RIVERMONT
SP55
SEWER RISING MAIN &
GRAVITY SEWER

Drawing Title:
**SEWER RISING MAIN
LAYOUT PLAN
SHEET 1**

Approval no: DEV-2026-WAR-5170

AMENDED IN RED

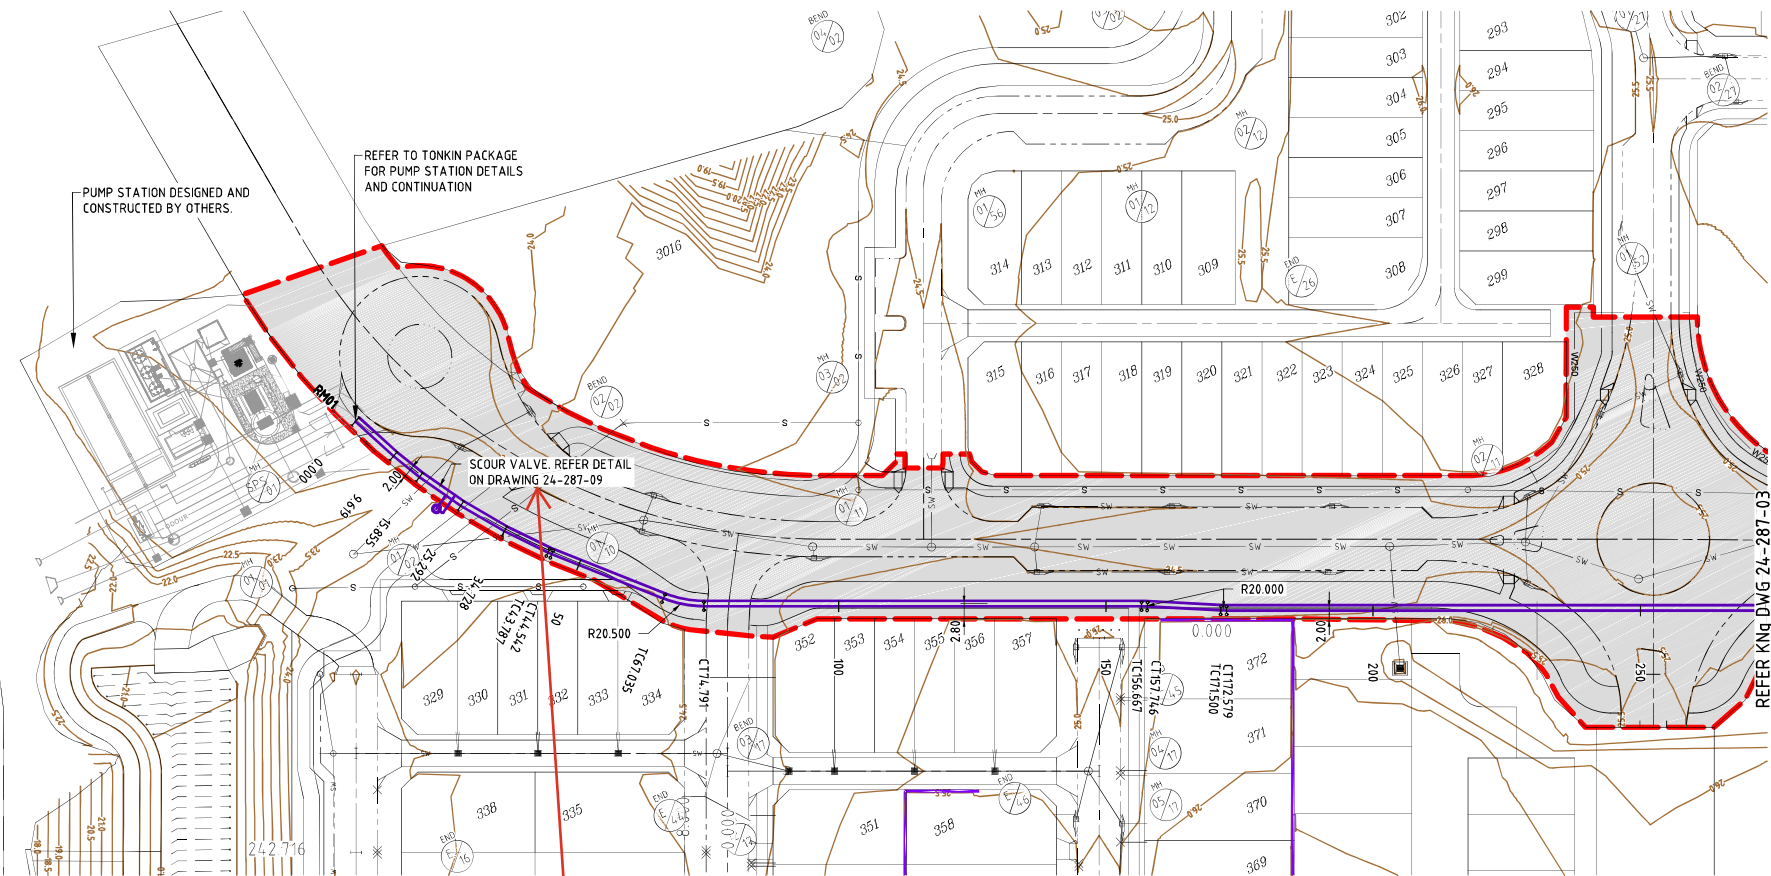
Drawings to be updated to
1. provide live connection
details to Gravity DN160
sewer.

2. include the live connect to
OCU and the extra MH.

3. correctly indicate scour valve
and air valve location.

RISING MAIN DISCHARGE MANHOLE DETAIL
SCALE 1:25

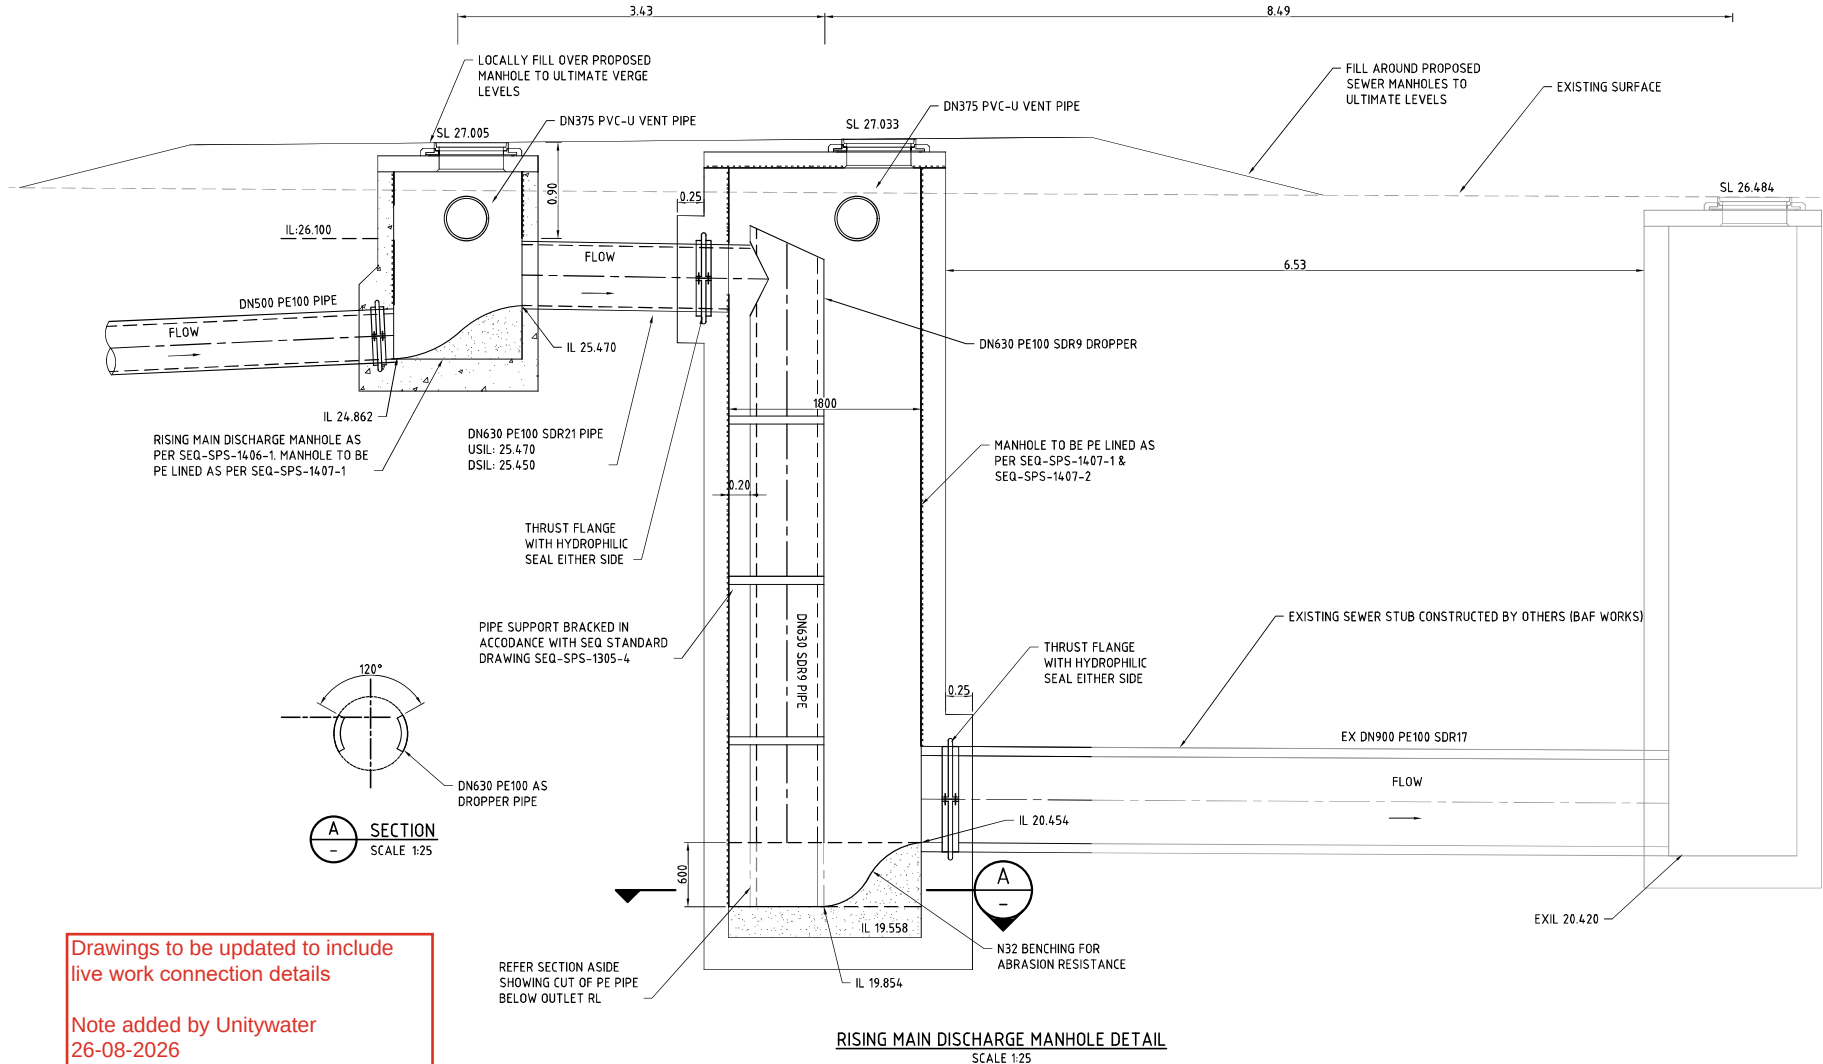
Drawings to be updated to include
live work connection details

GAS RELEASE VALVE AND SCOUR VALVE ARRANGEMENT
SCALE 1:25

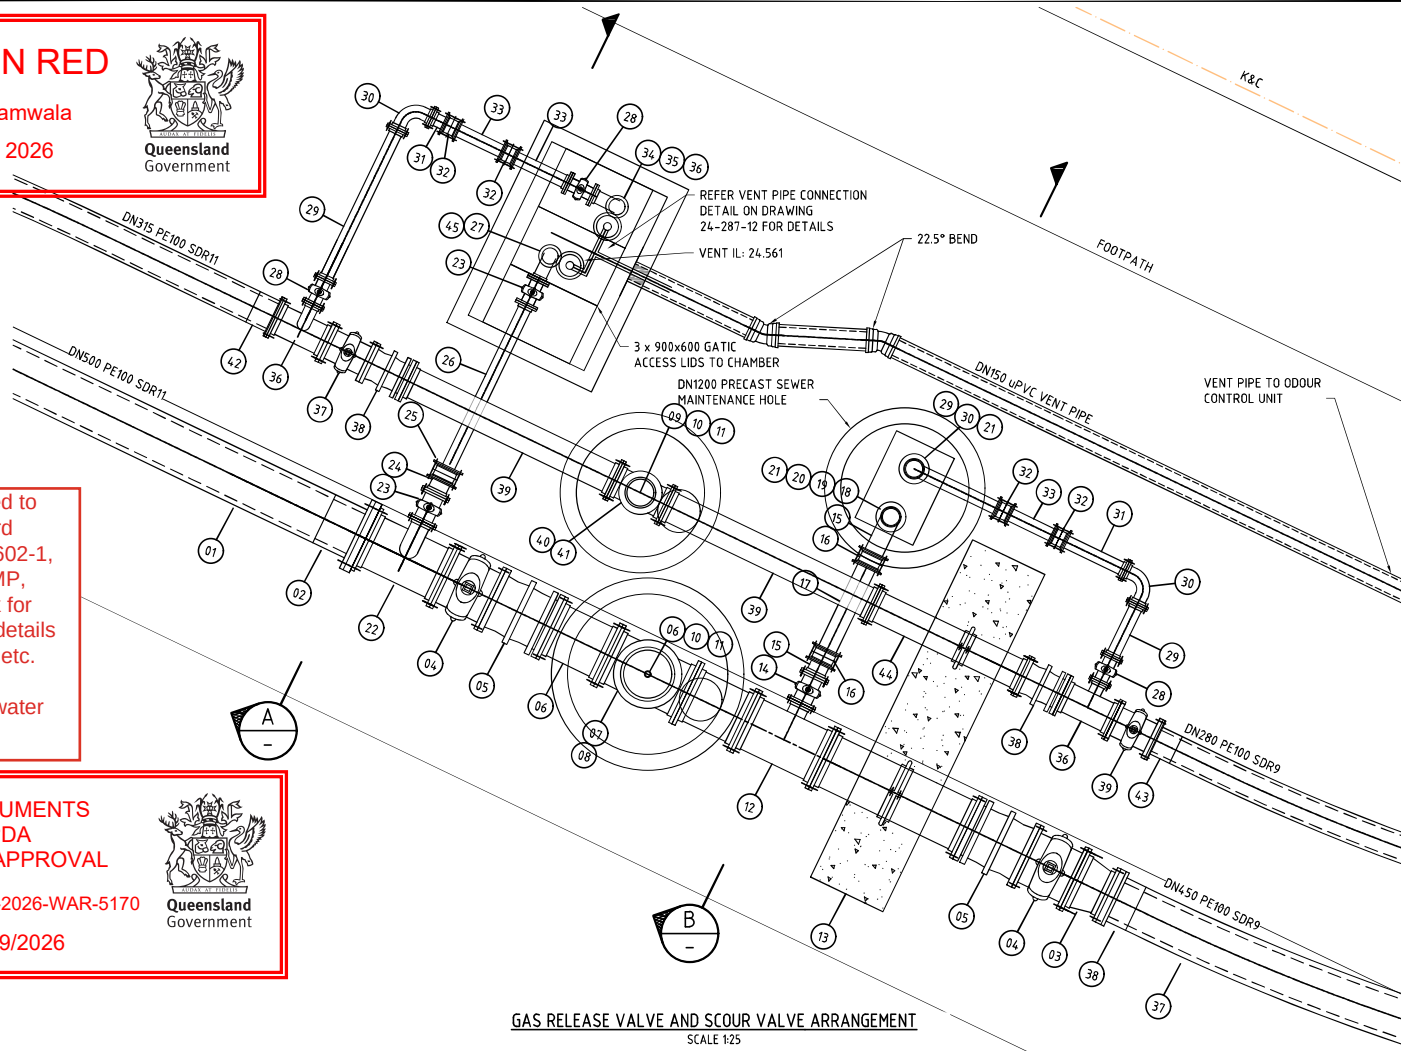
Drawing to be updated to reference the standard drawing SEQ-SPS-1602-1, including adding SUMP, ABFLEX, thrust block for DN315 Rising Main, details of pipe arrangement, etc.

Drawing Title: 17-49-23-10'00"
SEWER RISING MAIN
SCOUR VALVE DETAILS
SHEET 1

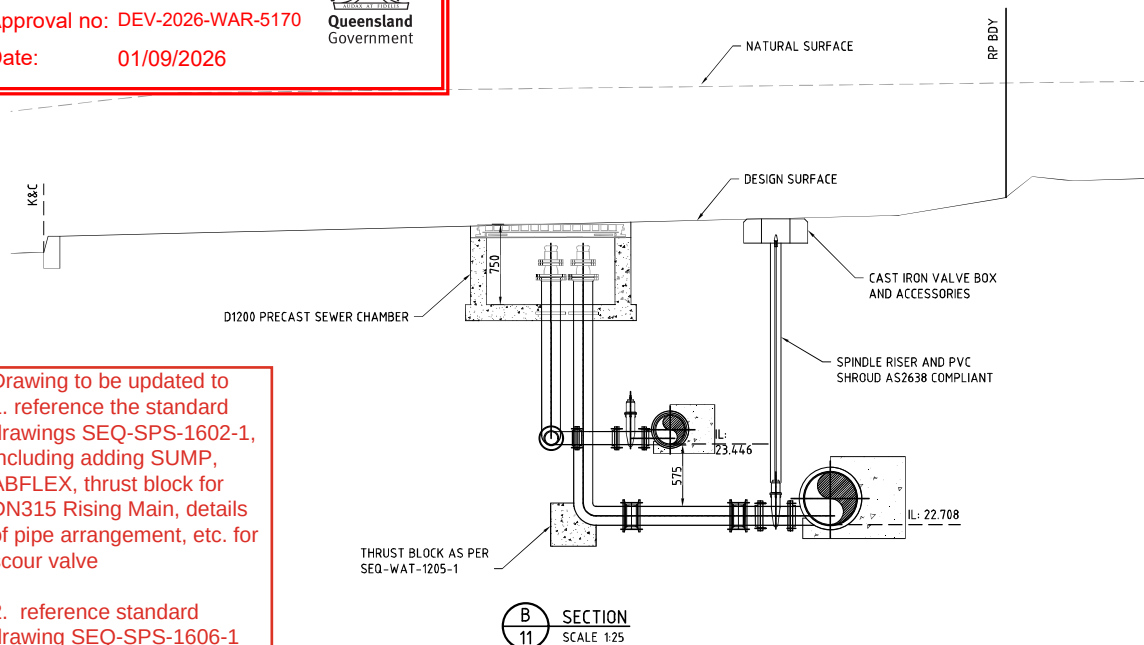
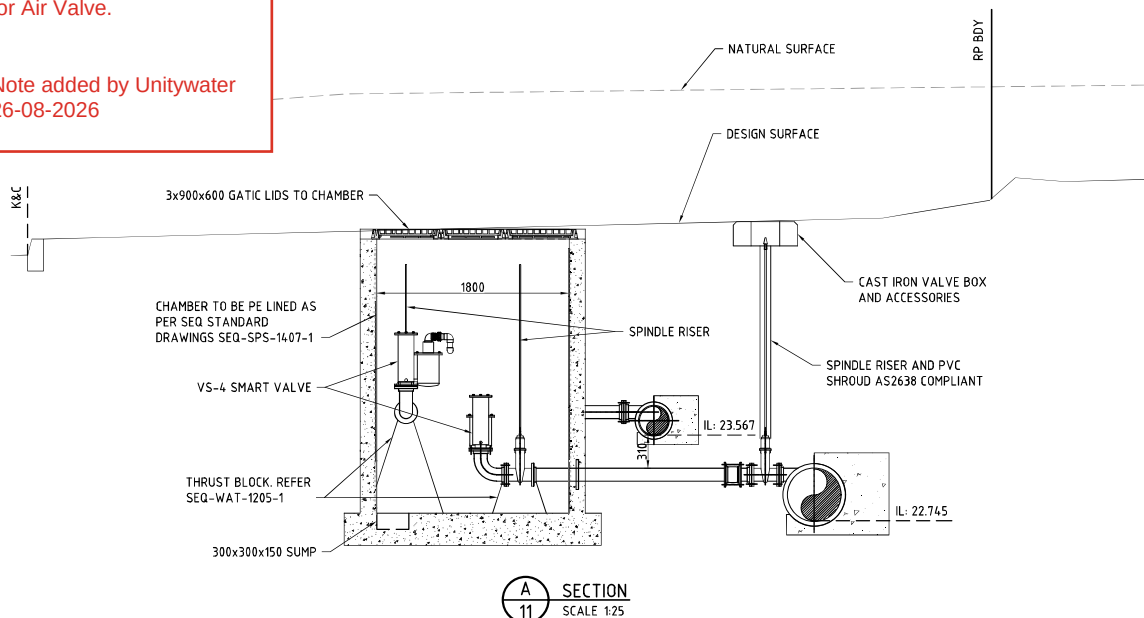
Drawing to be updated to
1. reference the standard
drawings SEQ-SPS-1602-1,
including adding SUMP,
ABFLEX, thrust block for
DN315 Rising Main, details
of pipe arrangement, etc. for
scour valve

2. reference standard
drawing SEQ-SPS-1606-1
for Air Valve.

SEWER RISING MAIN
SCOUR VALVE DETAILS
SHEET 2

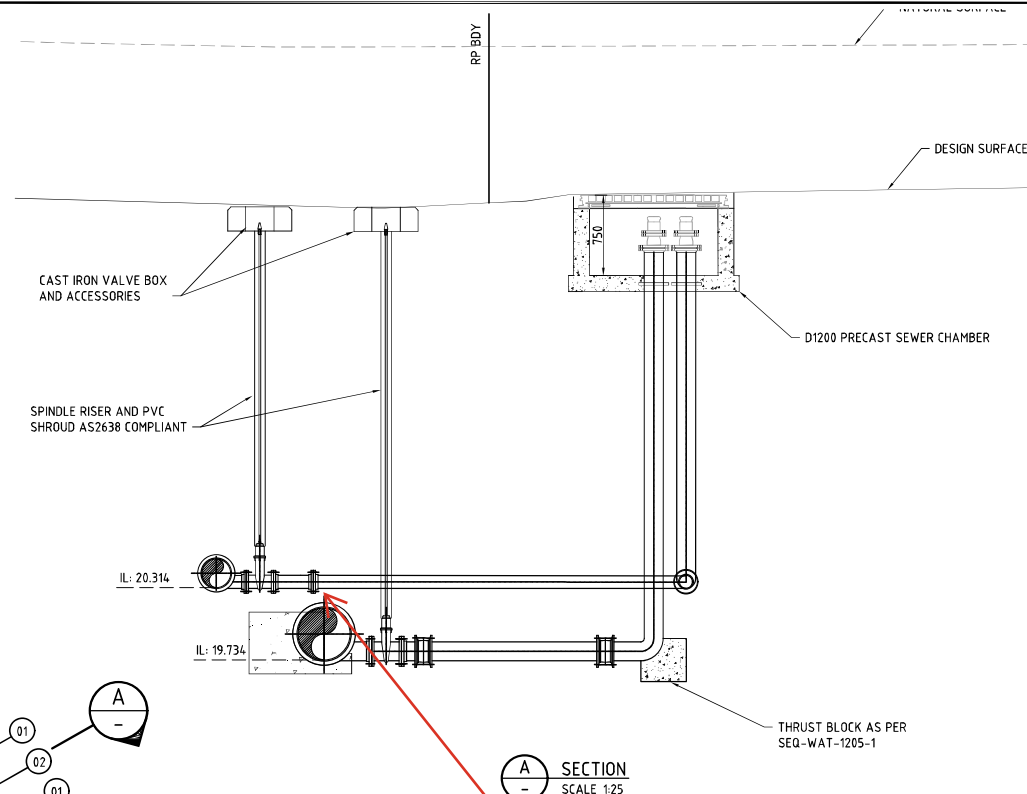
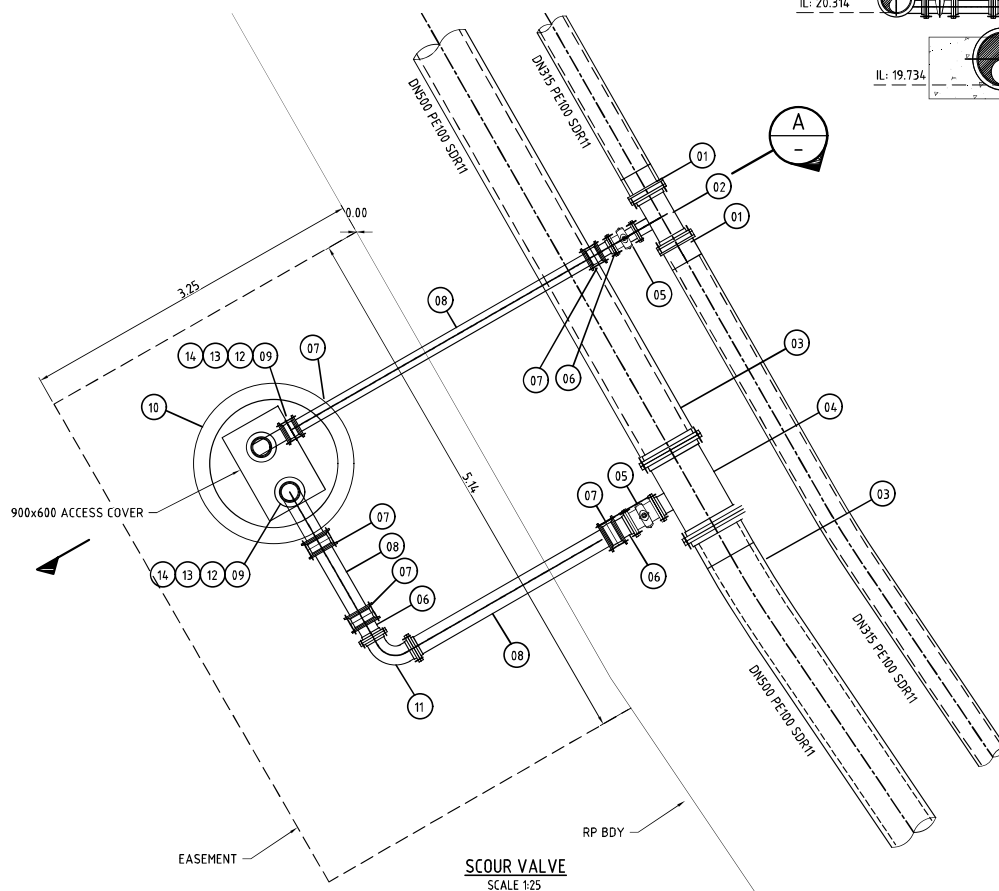
Drawing to be updated to

1. indicate the clearance between the scour pipe and DN500 Rising main.
2. reference the standard drawing SEQ-SPS-1602-1, including adding SUMP, ABFLEX, thrust block for DN315 Rising Main, details of pipe arrangement, etc.

SEWER RISING MAIN
ODOUR CONTROL UNIT
DETAILS SHEET 1

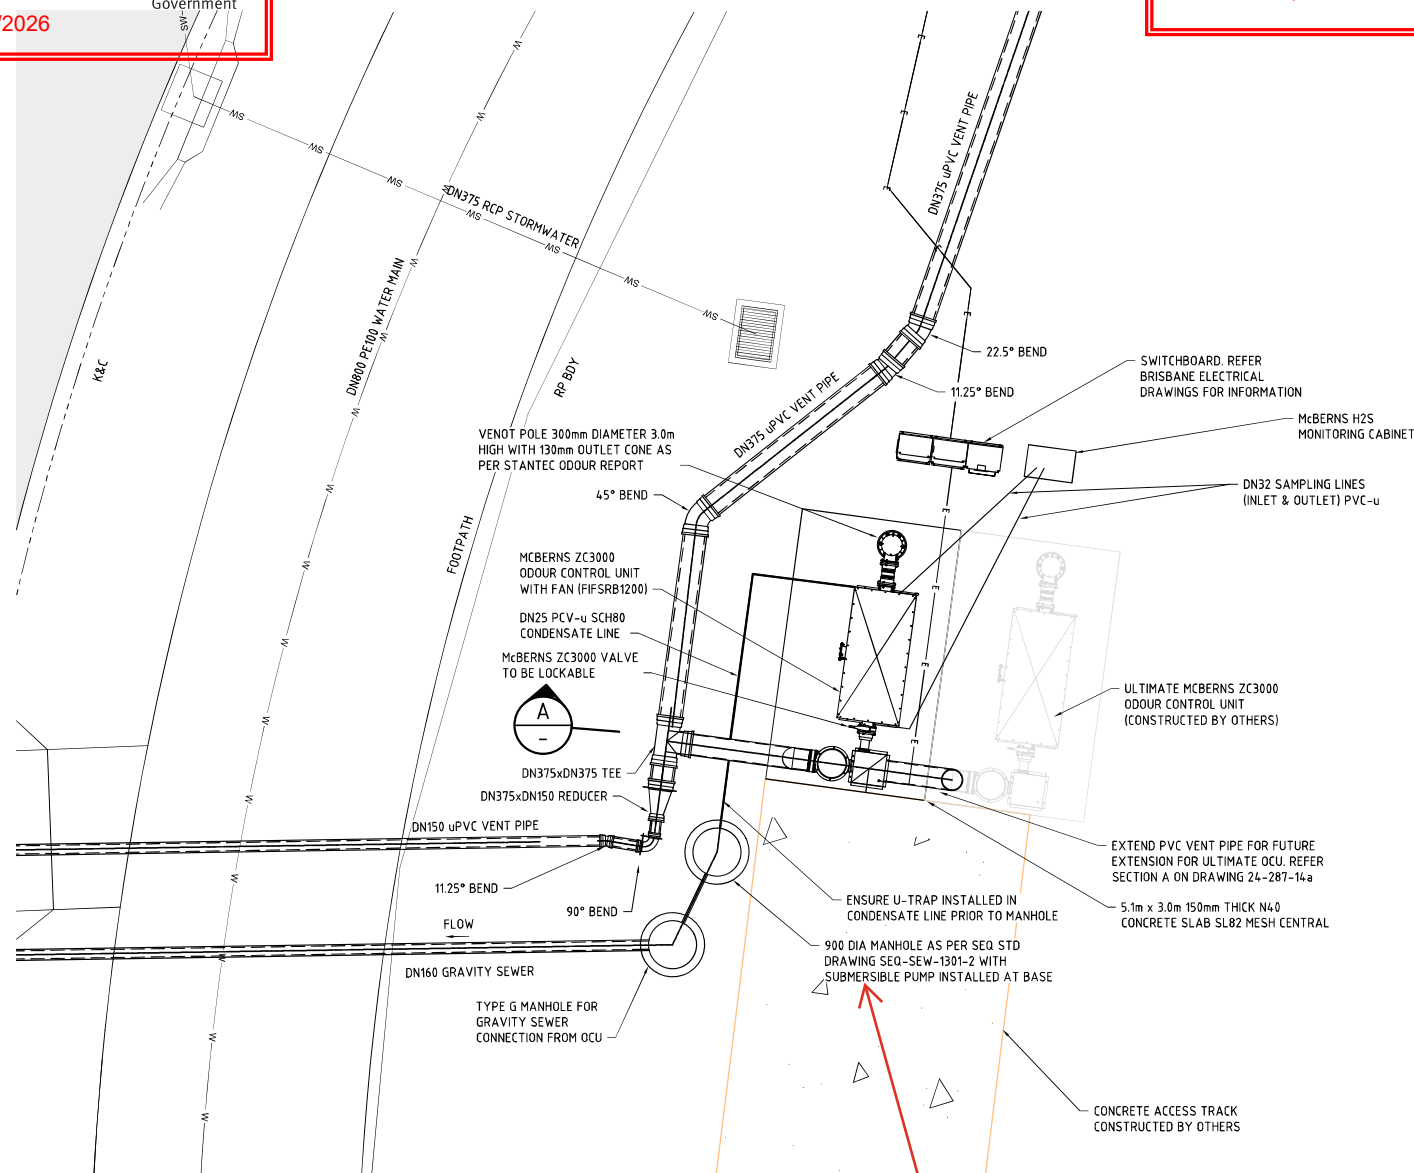
Drawing to be updated to provide details of the manhole and pump.
